From: Richard Dudley, *NRR*
To: gth *G. Hubbard, NRR*
Date: Thu, Apr 27, 2000 1:38 PM
Subject: Fwd: VB: Draft Final Technical Study SFP Risks at Decom NPPs

Questions/Comments on the NRC "Draft final technical study of spent fuel accidents risk at decommissioning nuclear power plants", 7590-01-P.

FIGURE 1: Envelope Ground Response Spectra for a (principal) horizontal GM direction, relating to, exceedance frequencies 10⁻⁵, 10⁻⁶ and 10⁻⁷ annual events per site and damping ratios 0.005, 0.02, 0.05, 0.07 and 0.10.

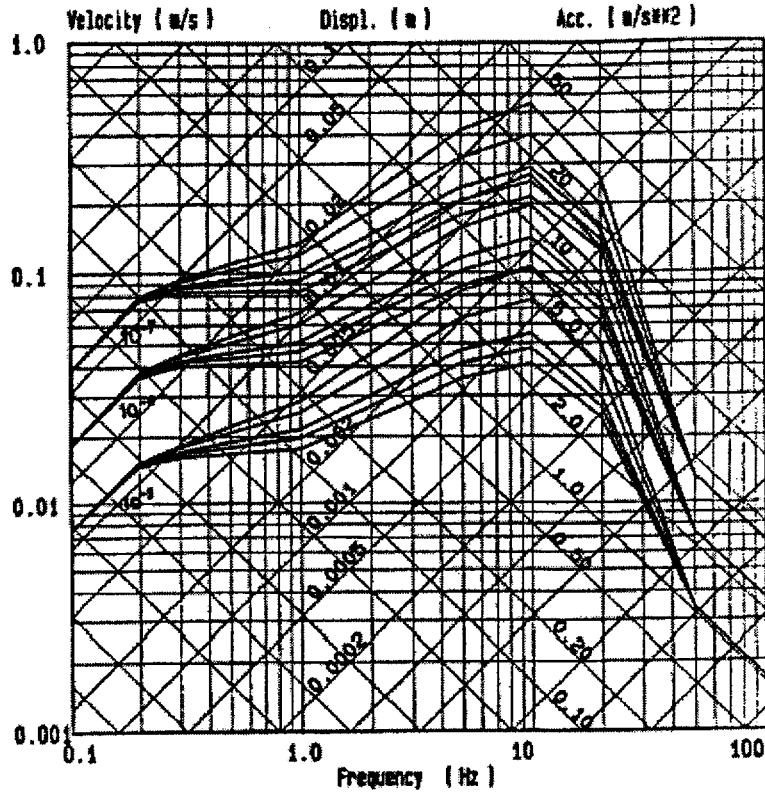
5. An US earthquake response spectra 10^{-5} /year (0.5g) is considered as a 10^{-7} in Sweden. Does this justify exemption from further consideration, due to low yearly frequency for Zr-fire? The SFP at the Swedish plant is calculated with an earthquake 0.1g, see response spectra Figure 1, and found to comply with the Swedish standard design standard (Boverkets Konstruktionsregler 94, BKR94).
